Accessibility Report

New Primary School in Murrumbateman 2 Fairley Street, Murrumbateman, NSW

Report No: MURR-DD-SSDA-RPT-0001
Revision: A
Date: 14 May 2021

Marked Plans

NEW PRIMARY SCHOOL IN MURRUMBATEMAN
2 FAIRLEY ST MURRUMBATEMAN NSW 2582
DRAWING NAME
SITE PLAN

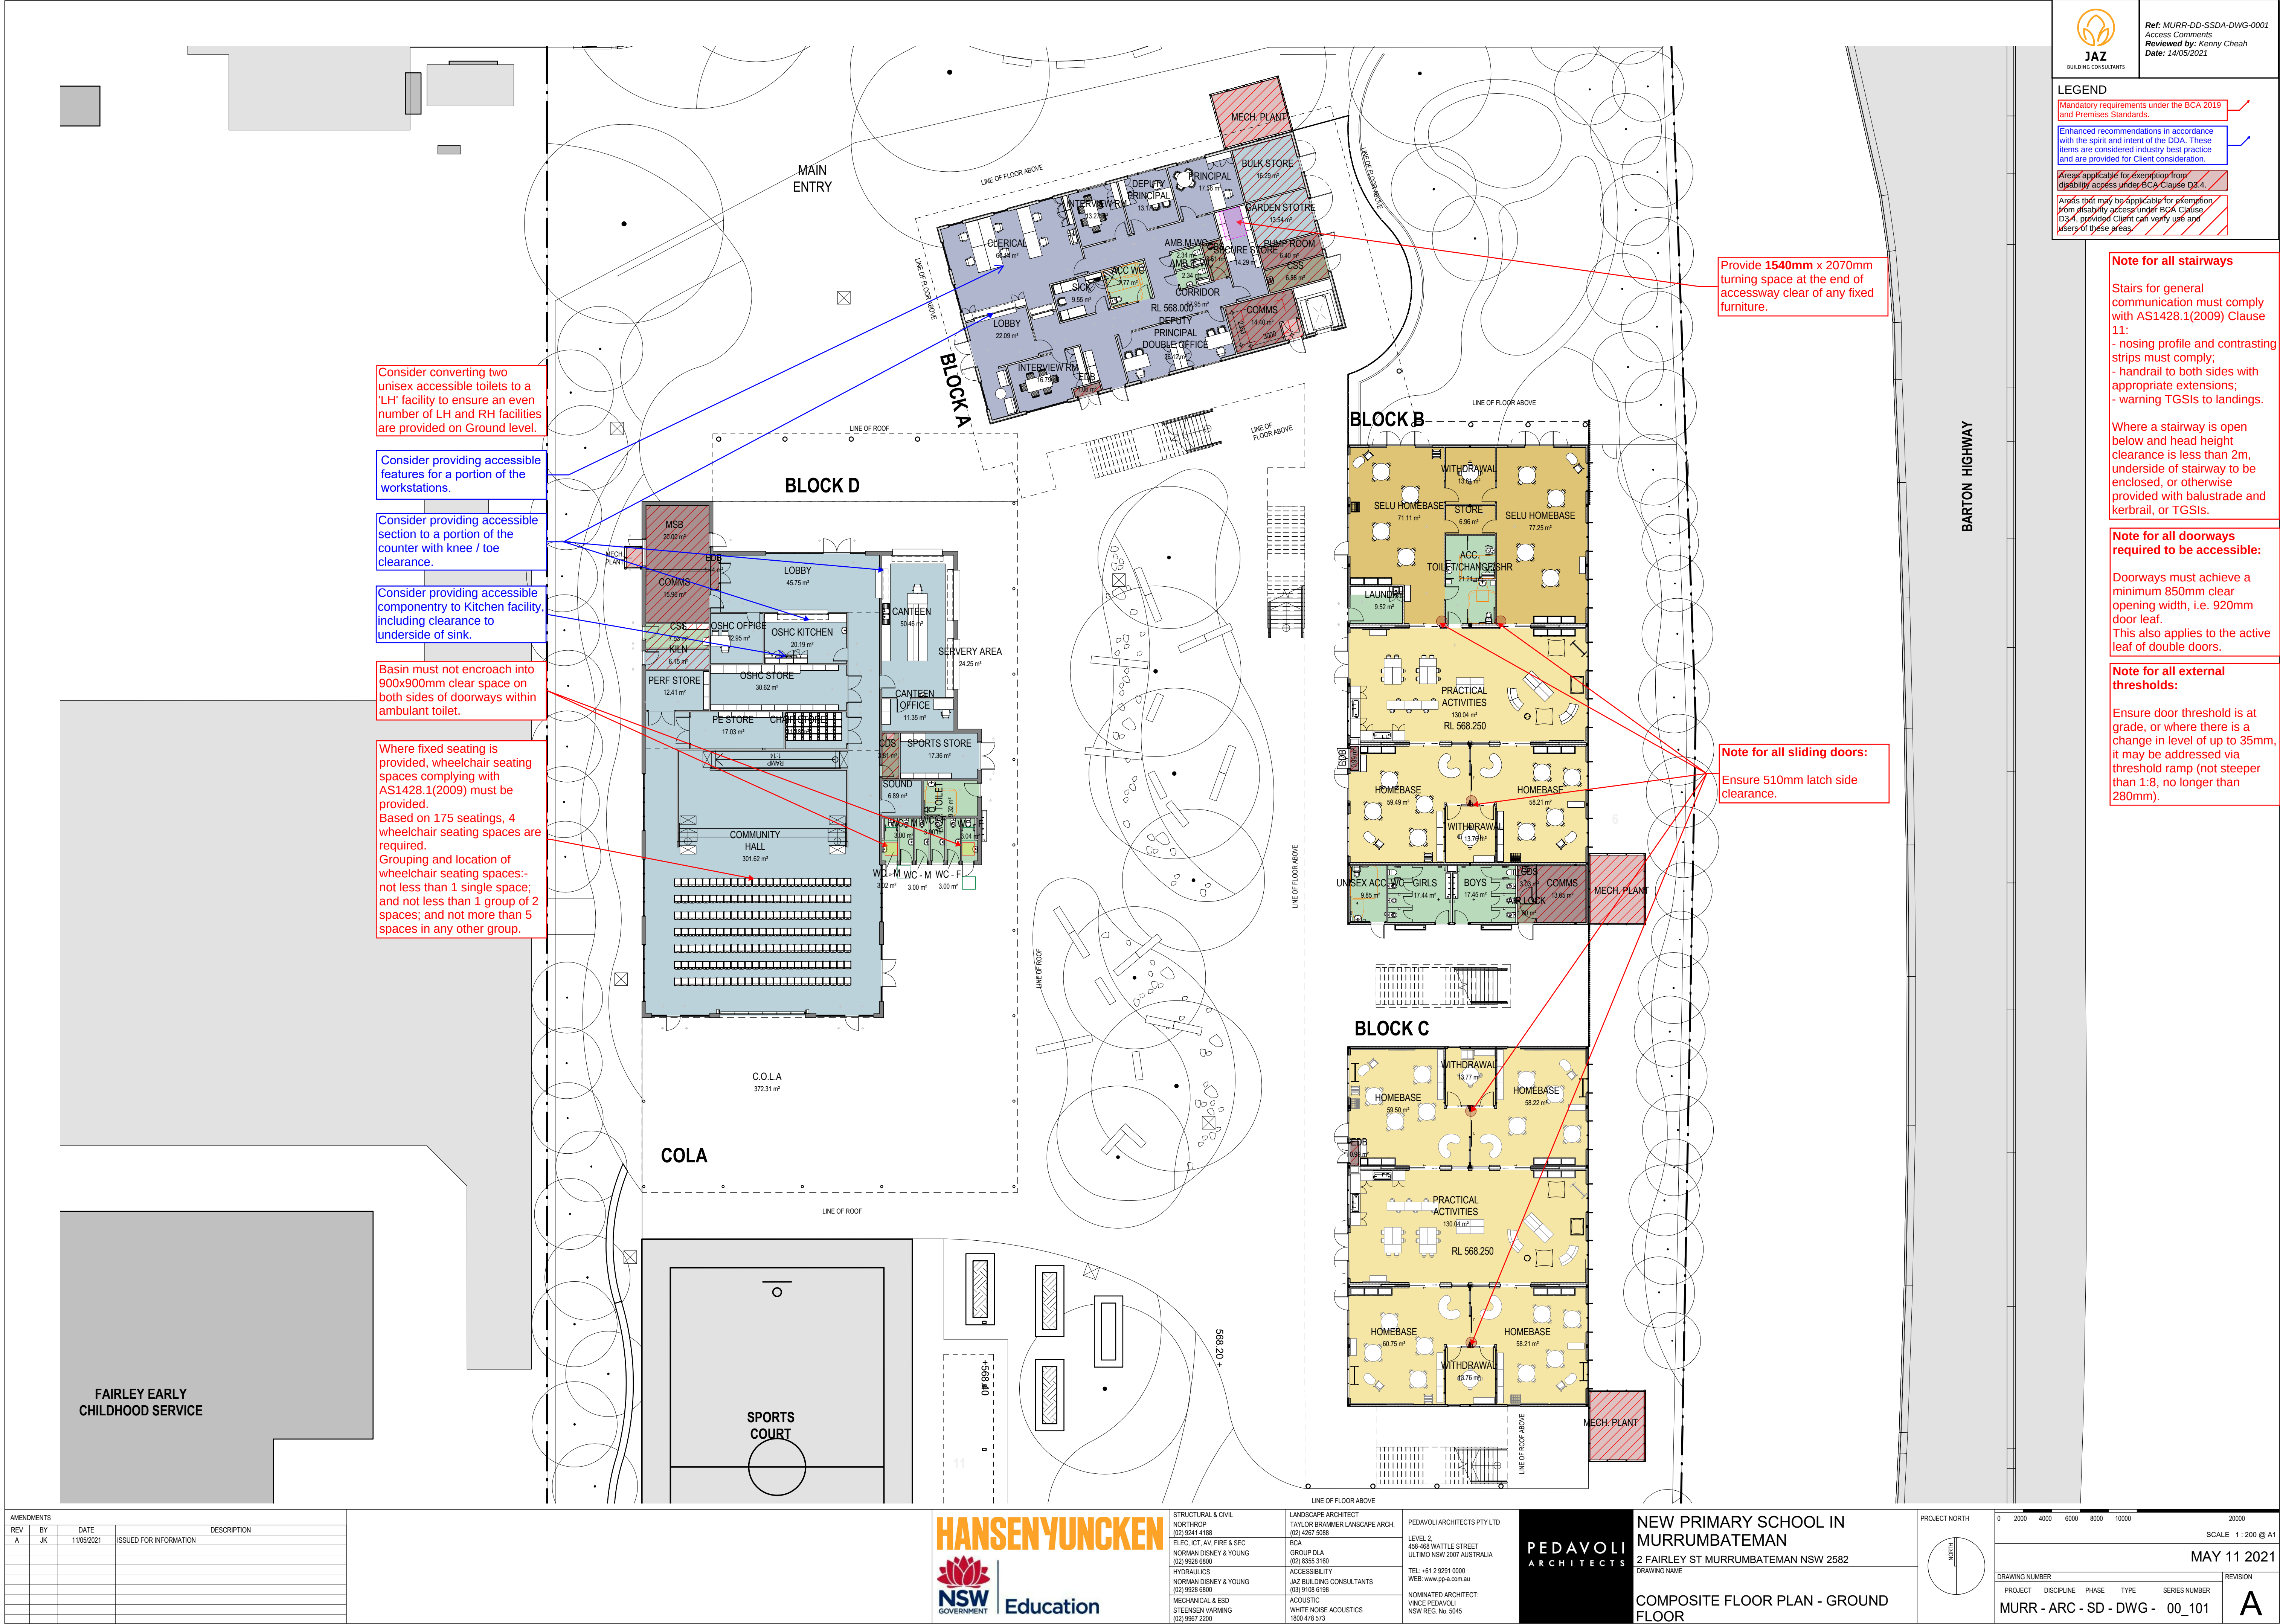
- warning TGSIs to landings.
- Where a stairway is open below and head height clearance is less than 2m, underside of stairway to be enclosed, or otherwise provided with balustrade and kerbrail, or TGSIs.
- Note for all doorways required to be accessible:
- Doorways must achieve a minimum 850mm clear opening width, i.e. 920mm door leaf.
- This also applies to the active leaf of double doors.
- Note for all external thresholds:
- Ensure door threshold is at grade, or where there is a change in level of up to 35mm, it may be addressed via threshold ramp (not steeper than 1:8, no longer than 280mm).

COMPOSITE FLOOR PLAN - GROUND FLOOR

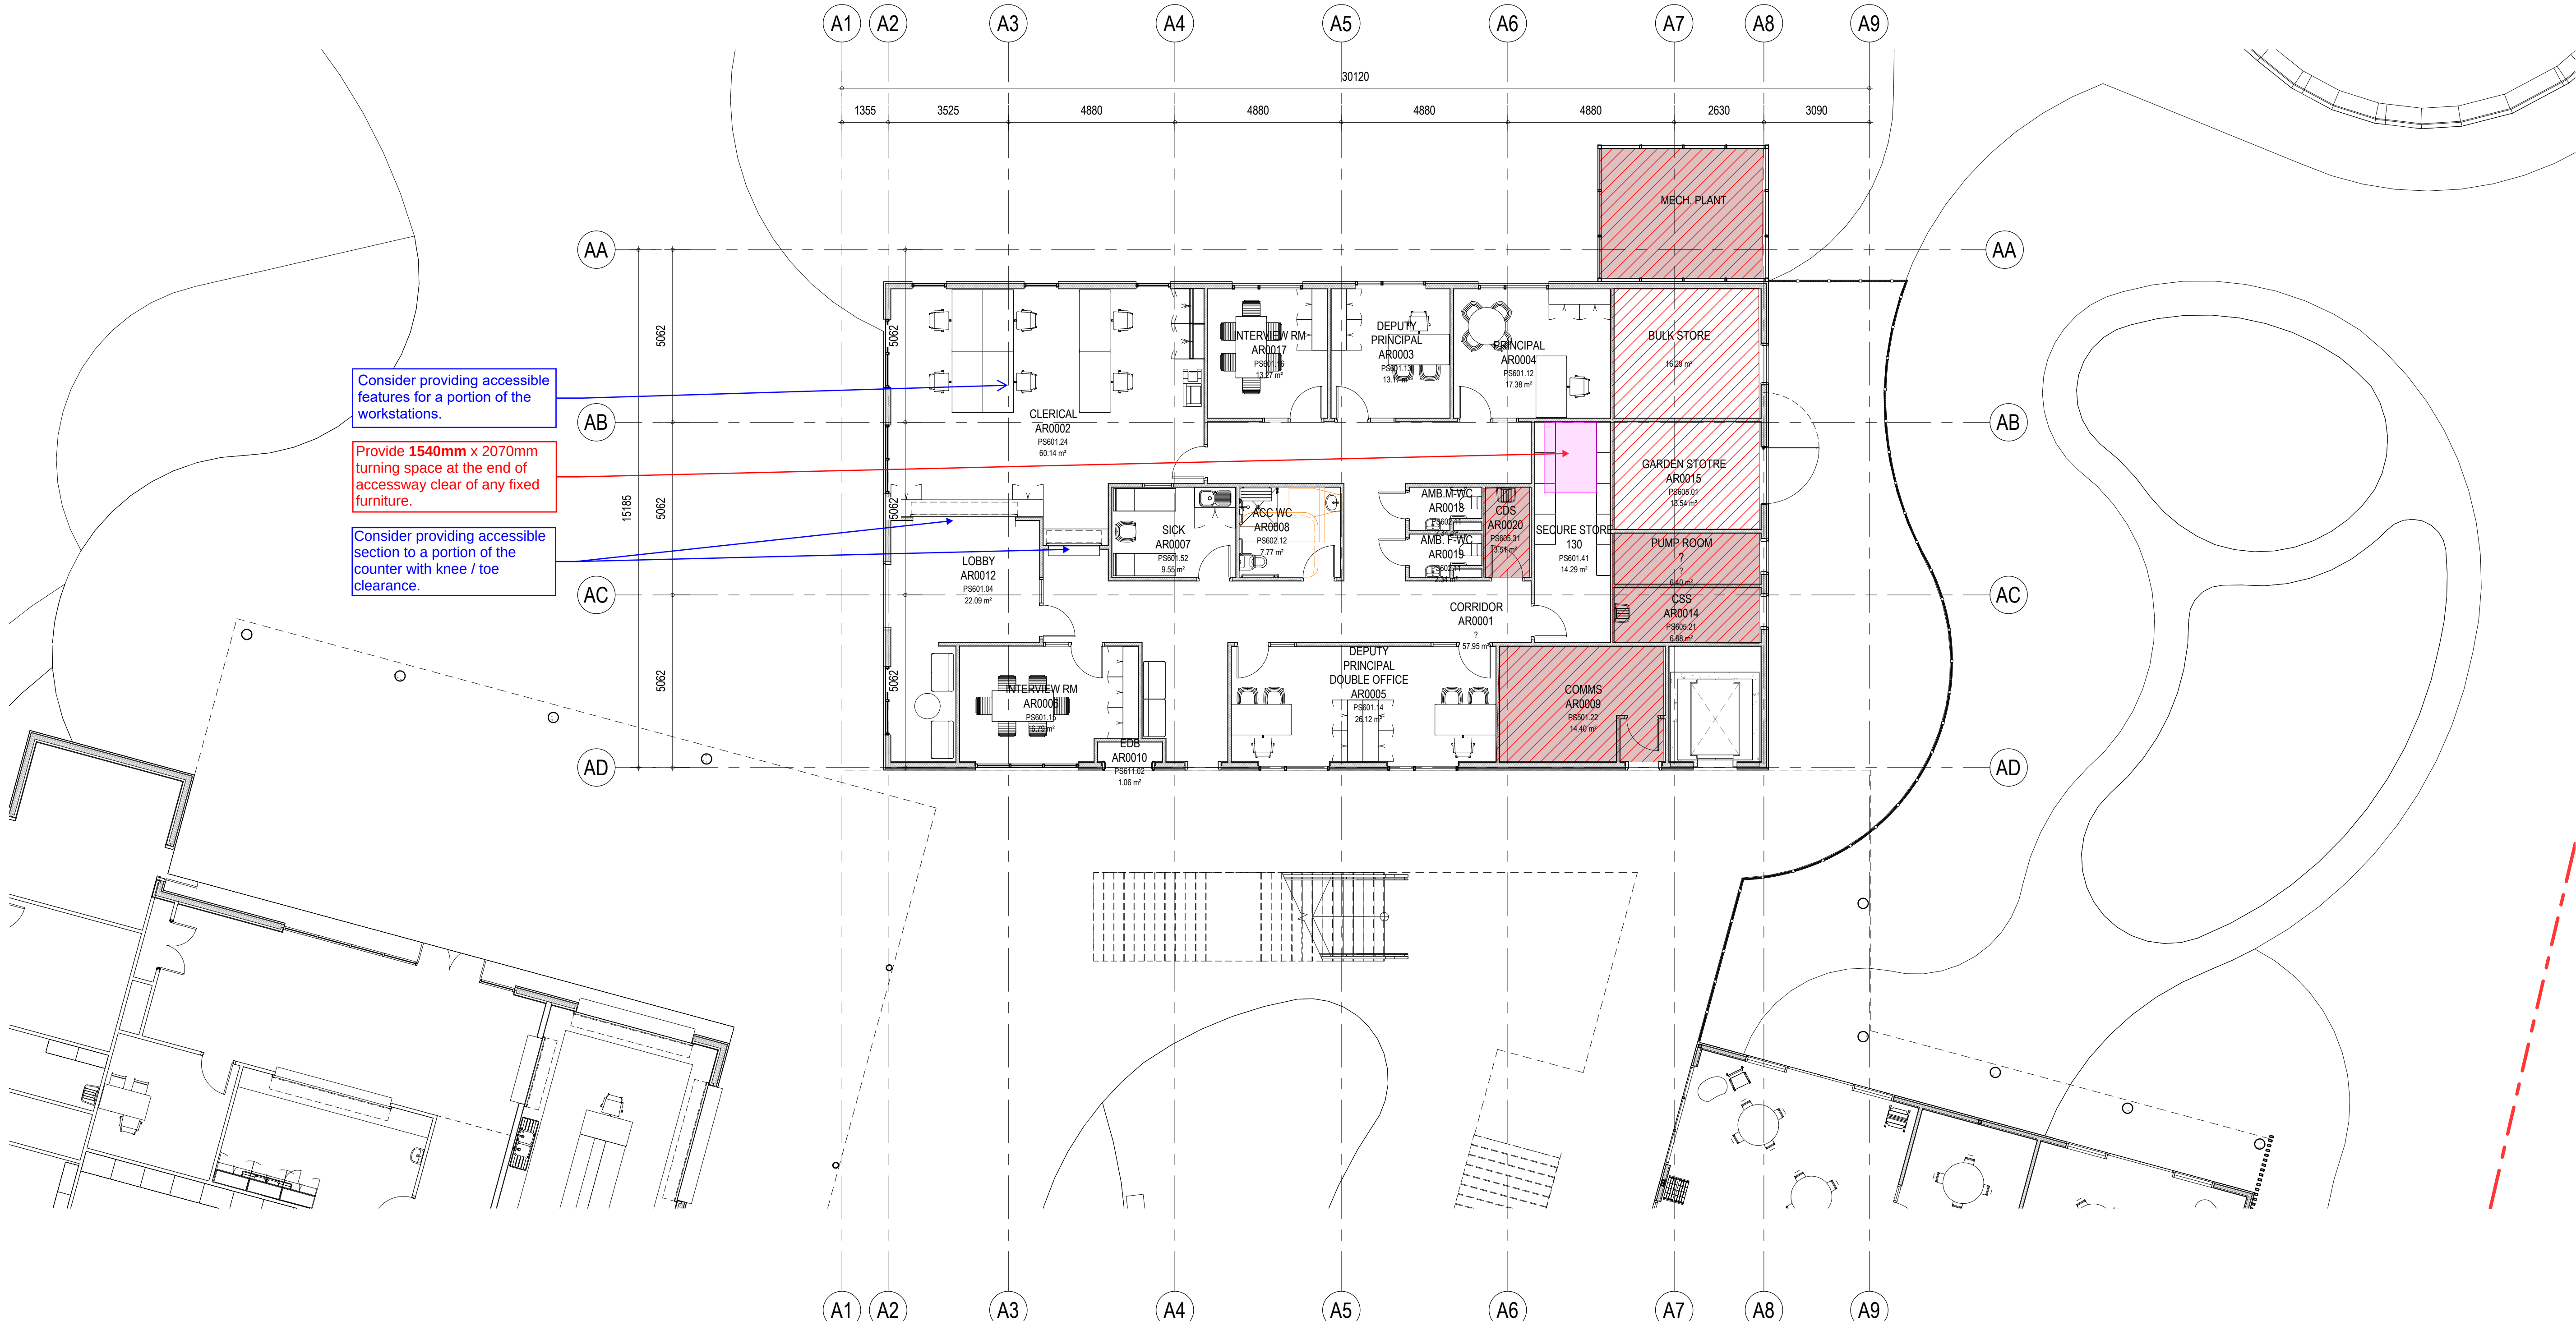
Ensure door threshold is at grade, or where there is a change in level of up to 35mm, it may be addressed via threshold ramp (not steeper than 1:8, no longer than 280mm).

- Ensure 530mm latch side clearance to doorway clear of any fixed furniture.
Provide **1540mm** x 2070mm turning space at the end of accessway clear of any fixed furniture.
- Convert this facility to a 'LH' facility to ensure an even number of LH and RH facilities are provided on Level 1.
- Consider providing accessible section to a portion of counter with knee / toe clearance.
- Note for all sliding doors:**

NEW PRIMARY SCHOOL IN
MURRUMBATEMAN
2 FAIRLEY ST MURRUMBATEMAN NSW 2582
DRAWING NAME
BLOCK C - GROUND FLOOR -
FURNITURE PLAN

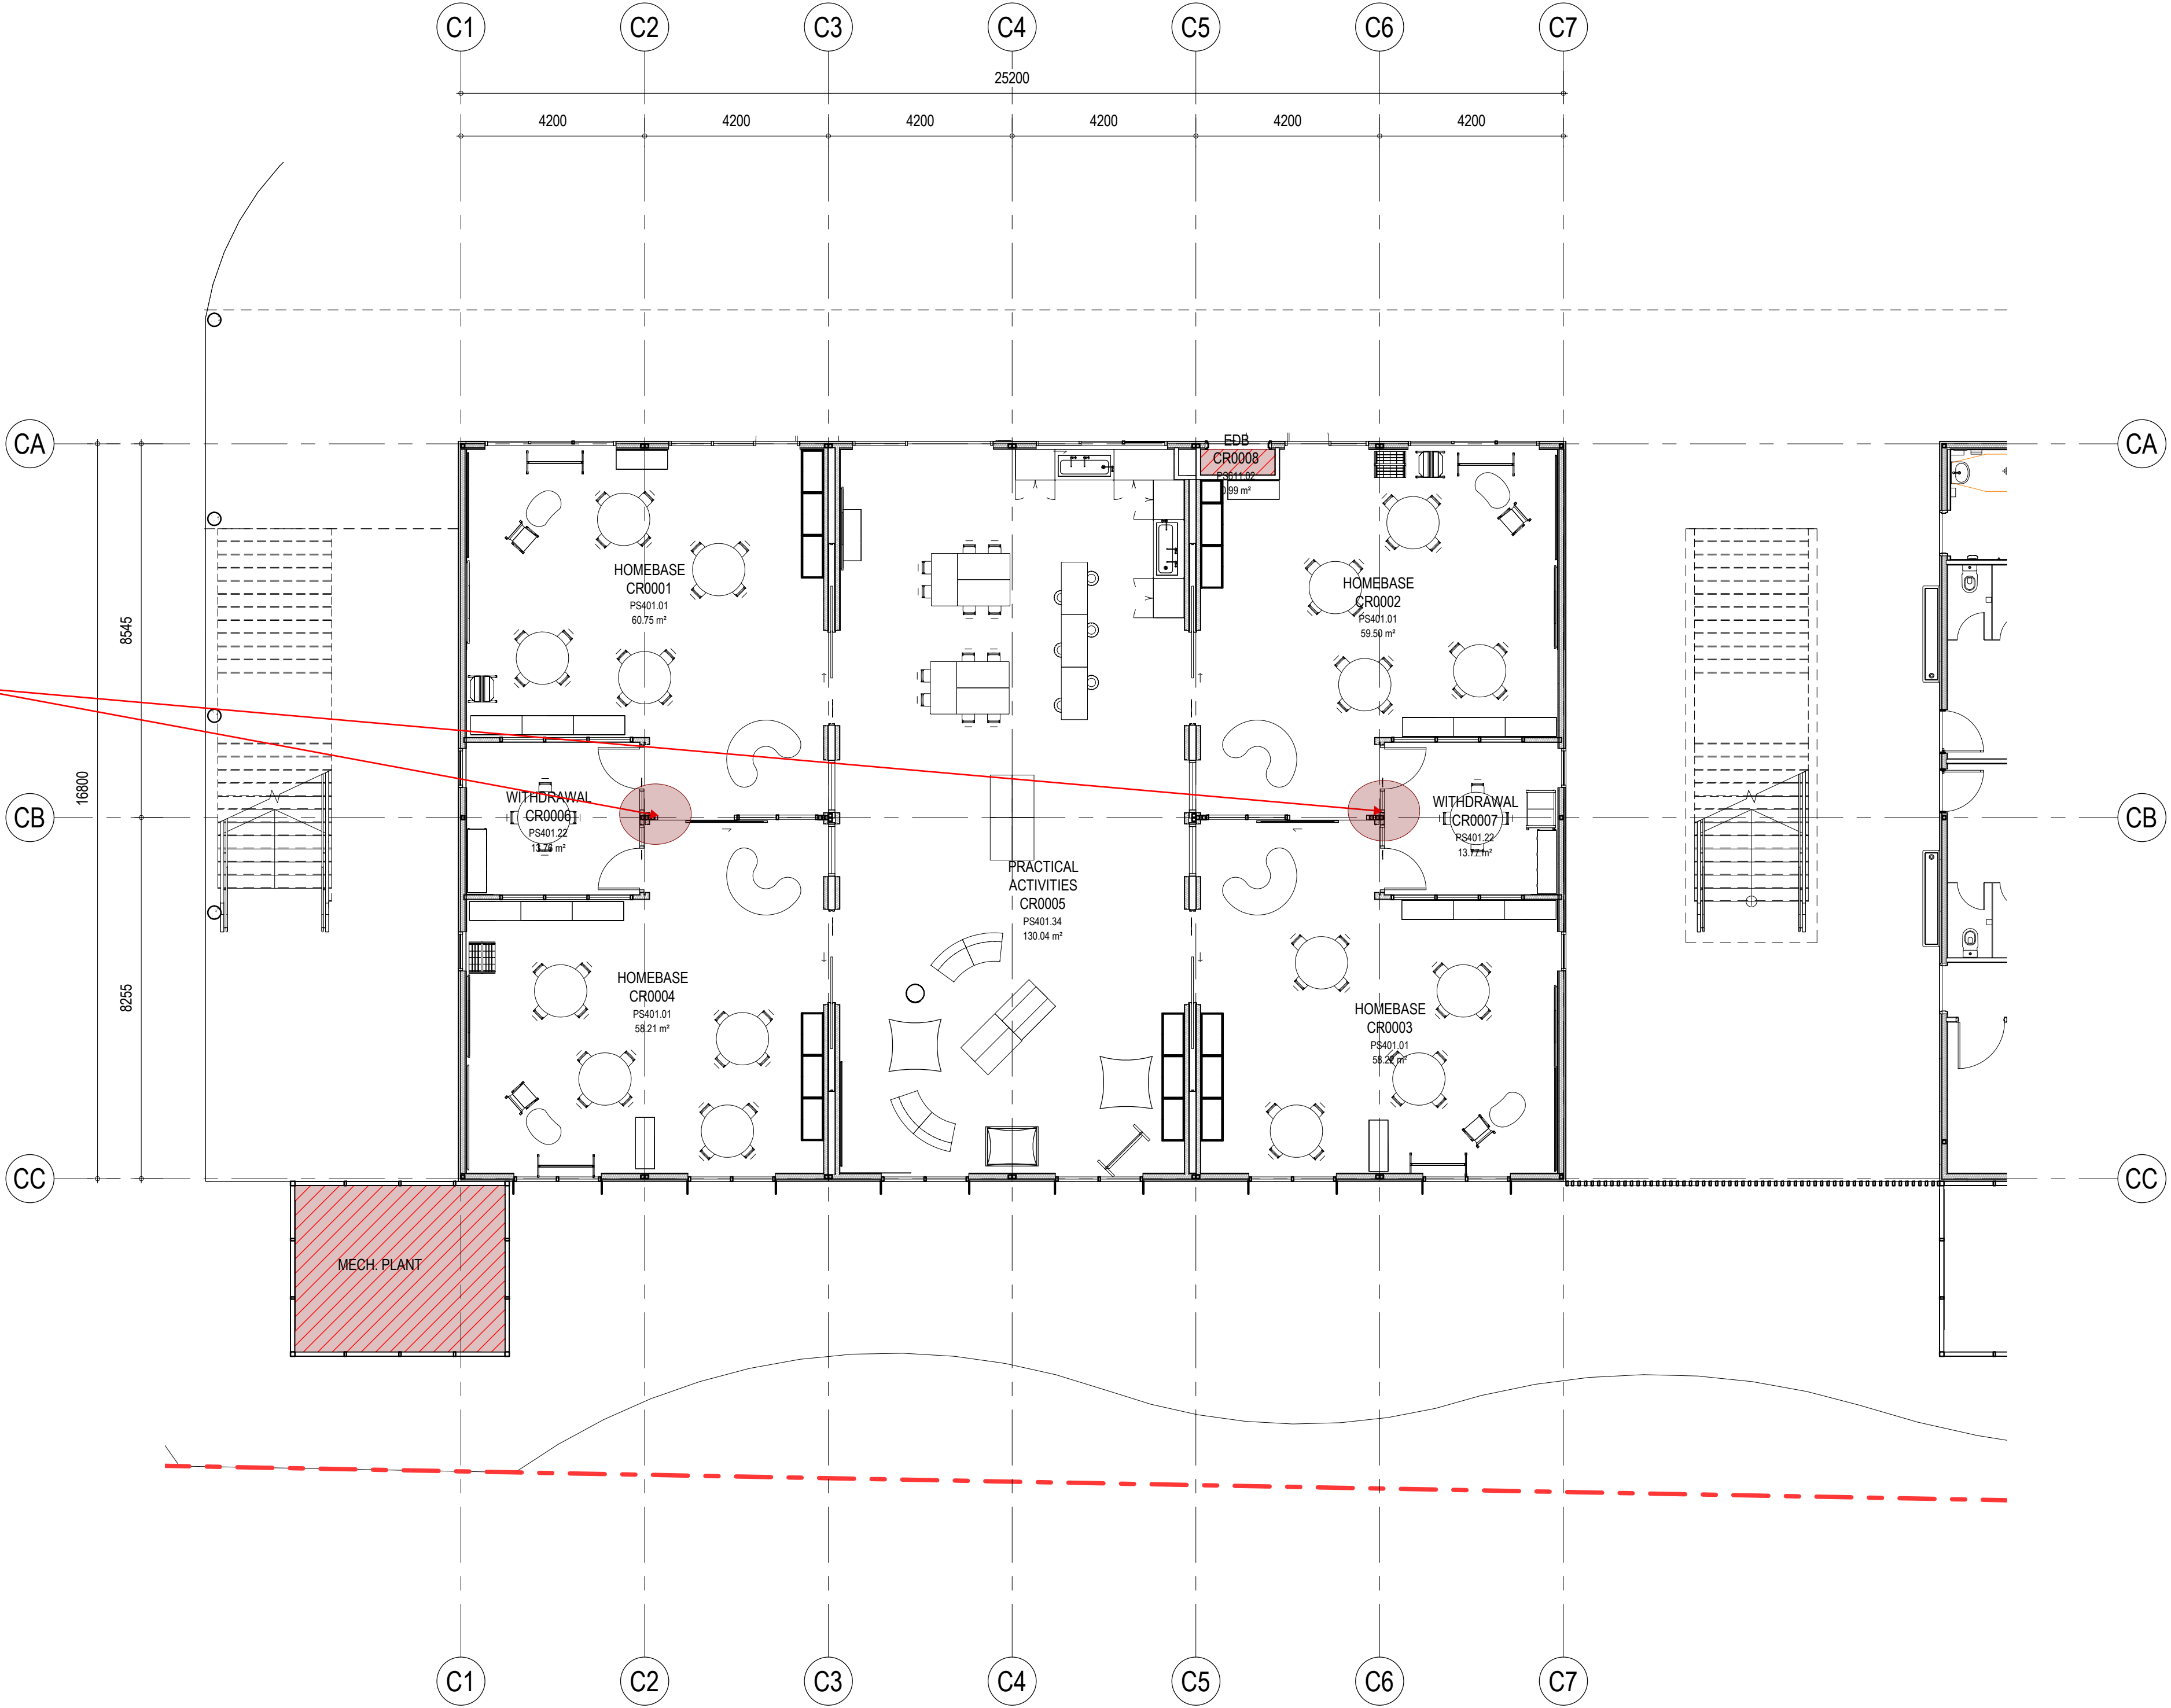
Note for all sliding doors:
Ensure 510mm latch side
clearance.
